Mark	Date	By	CHK	App.	Reason
PL7	19/12/22	ED	-	-	ISSUED FOR PLANNING ALTERATIONS ADDITIONAL INFORMATION
PL6	23/03/22	ED	-	-	ISSUED FOR FURTHER PLANNING ALTERATIONS

PLANNING ALTERATIONS 2021 (A.1.)

Job Title
PROPOSED DEVELOPMENT AT KINGSWOOD BUSINESS PARK, BALDONNEL, DUBLIN 22

Drawing Title
DRAINAGE & WATERMAIN LAYOUT

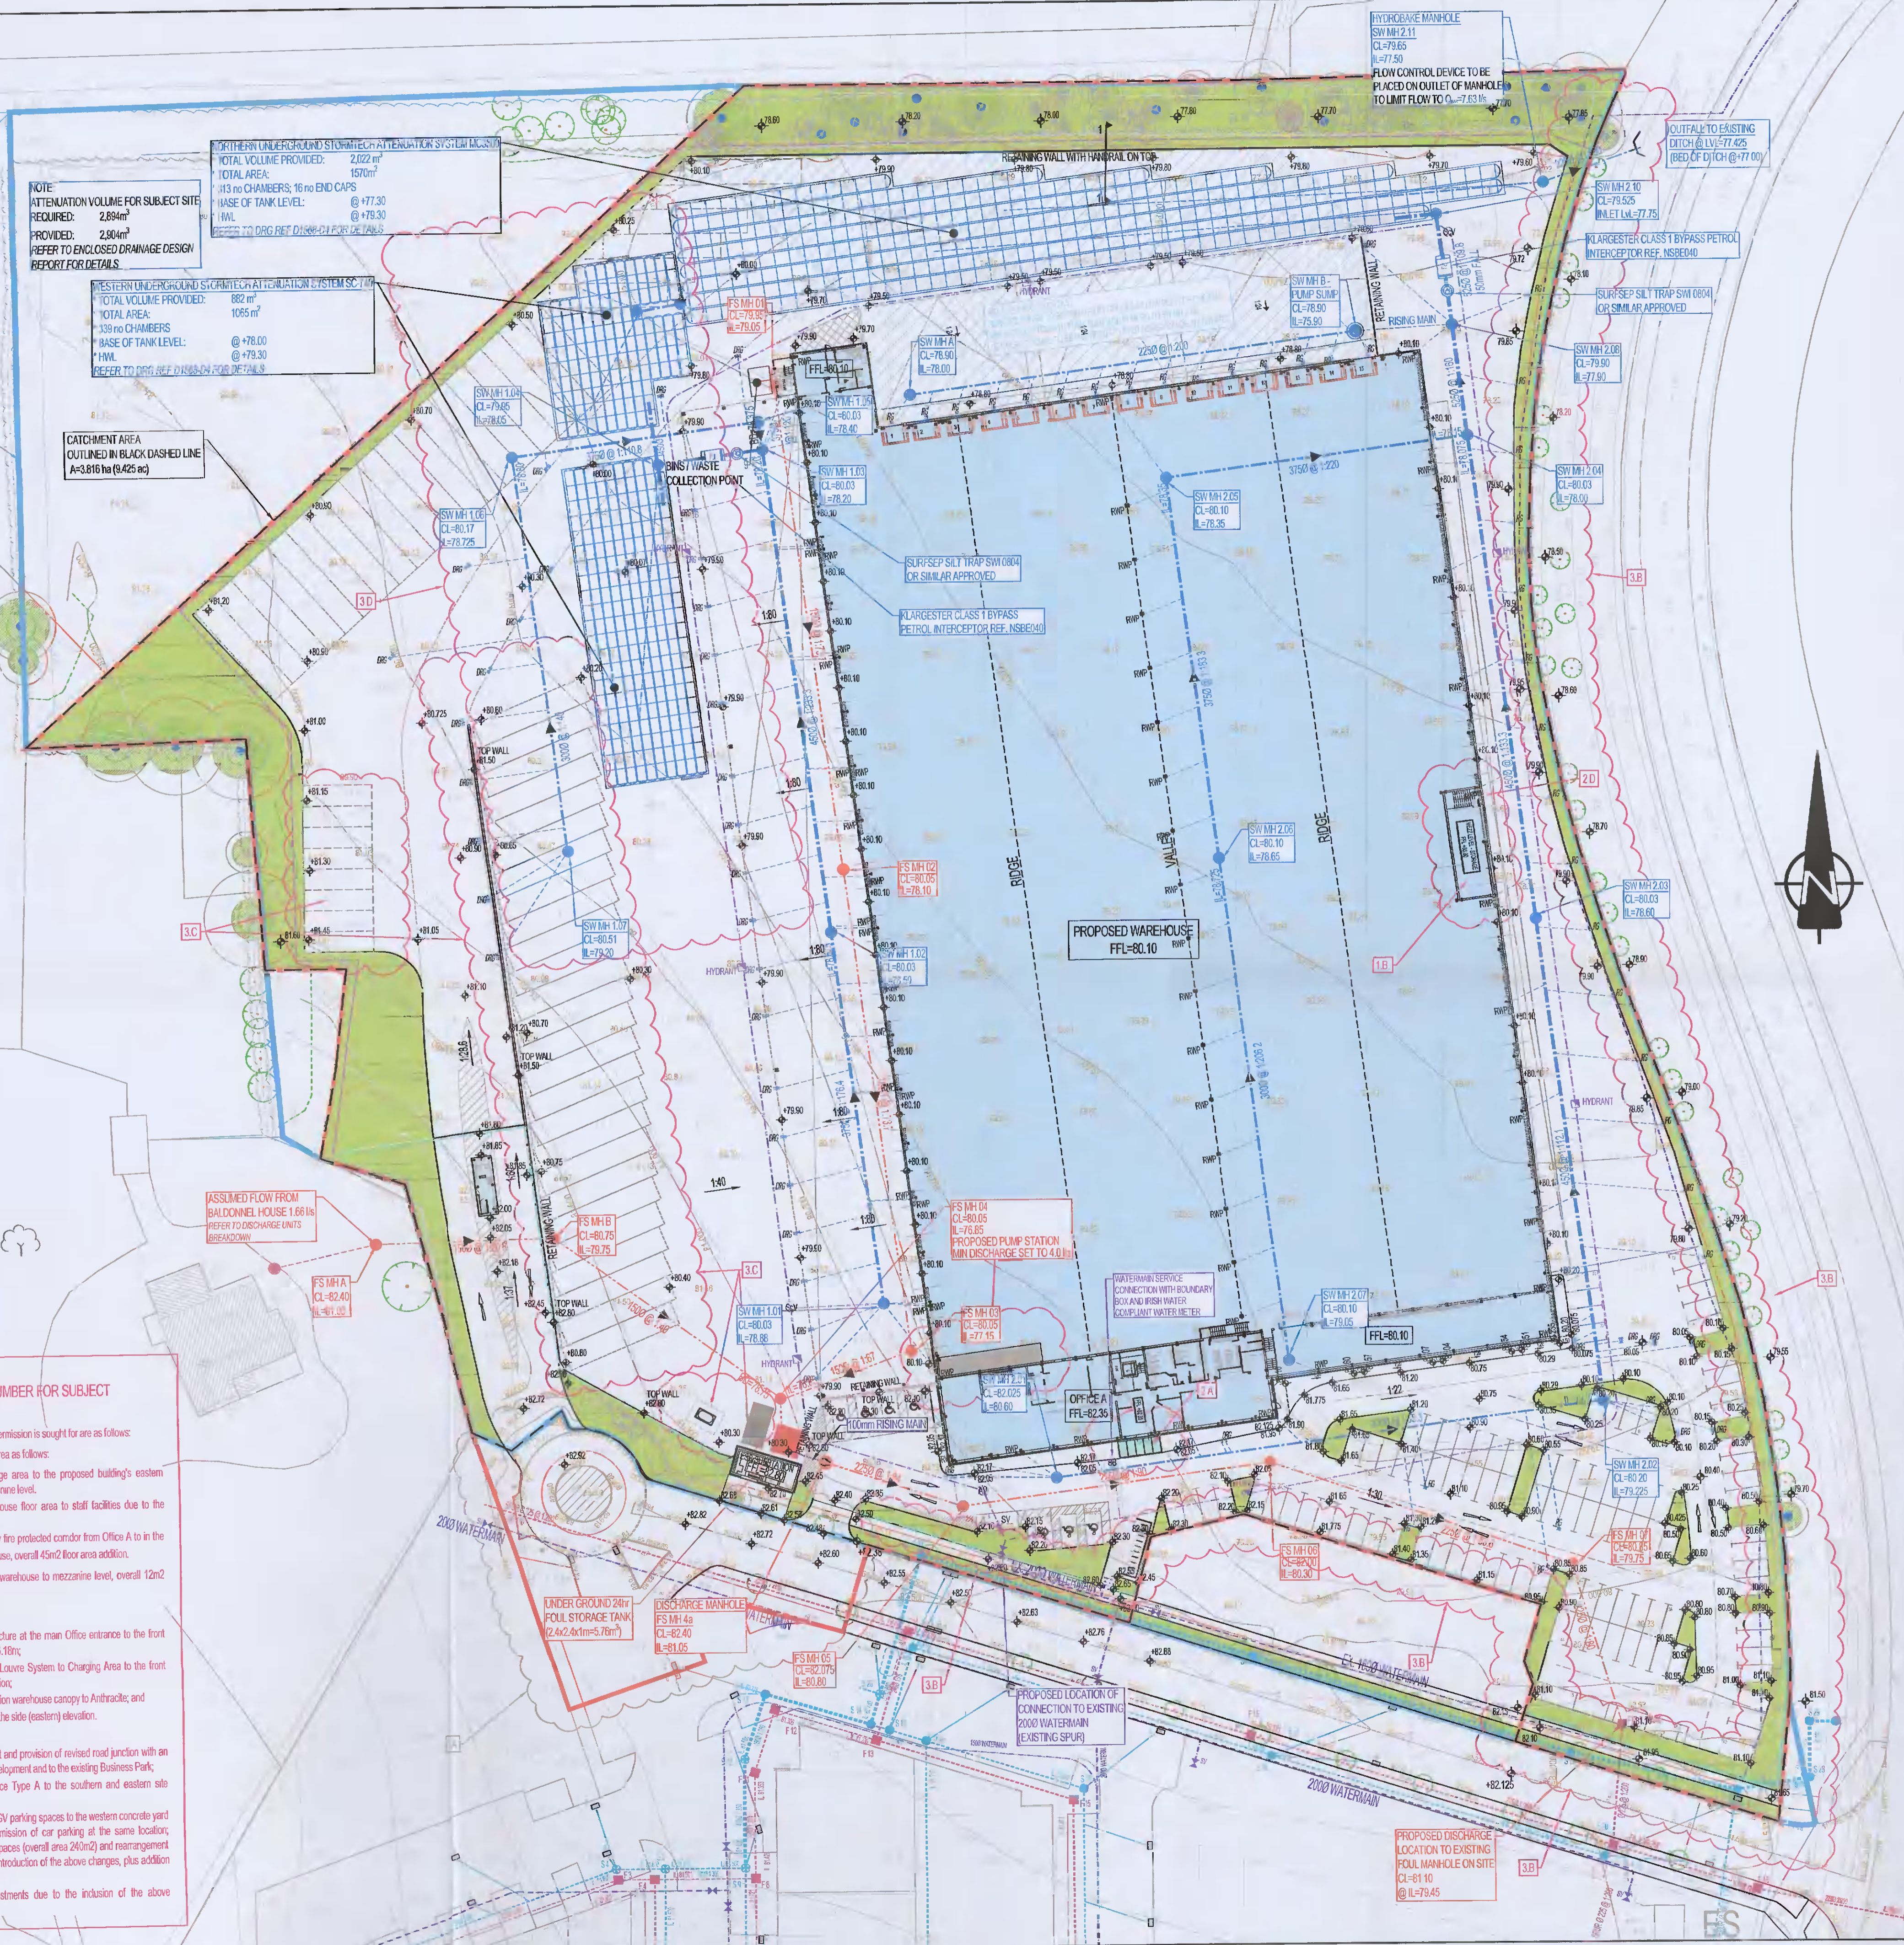
The subject alterations for which Planning Permission is sought for are as follows:

1. Reconfiguration of the ground floor area as follows:
 - A. Provision of a new ancillary storage area to the proposed building's eastern elevation measuring 75m², at mezzanine level.

- B. Change of Use of 57m² of warehouse floor area to staff facilities due to the following:
 - B.1. Addition of single storey fire protected corridor from Office A to in the south-west corner of the warehouse, overall 45m² floor area addition.

- B.2. Addition of stairs from warehouse to mezzanine level, overall 12m² floor area addition.
2. Elevation alterations:
 - A. Introduction of covered glazed structure at the main Office entrance to the front (southern) elevation, overall height 6.10m.

- B. Introduction of Integrated Modular Louvre System to Charging Area to the front (southern) and side (eastern) elevation.
 - C. Change of colour of southern elevation warehouse canopy to Anthracite; and

- D. Introduction of fire escape doors to the side (eastern) elevation.
3. Site plan alterations:
 - A. Omission of an existing roundabout and provision of revised road junction with an access/egress to the proposed development and to the existing Business Park;

- B. Provision of a new boundary fence Type A to the southern and eastern site boundary;
 - C. Introduction of additional 26 No. HOV parking spaces to the western concrete yard (overall area 1547m²) and the omission of car parking at the same location; introduction of 8 No. van parking spaces (overall area 240m²) and rearrangement of car parking spaces due to introduction of the above changes; plus addition of gas tank and generator; and

- D. Associated drainage layout adjustments due to the inclusion of the above alterations.

NOTE: DRAINAGE ARRANGEMENT IN PRINCIPAL REMAIN THE SAME AS THE PREVIOUSLY GRANTED APPLICATIONS REG. REF. S0184/014; S0184/008 & S0204/007. FOUL SEWER NETWORK HAS BEEN REDESIGNED AS PER NEW ROUTE AND NEW LOCATION OF PUMPING STATION, AS SHOWN. SURFACE WATER DRAINAGE HAS BEEN SLIGHTLY ADJUSTED IN A FORM OF CHANGING THE LOCATION OF SURFACE WATER ATTENUATION SYSTEM AND THEIR CROSS SECTION. REFER TO ENCLOSED DRAINAGE DESIGN REPORT FOR REVISED CALCULATIONS.
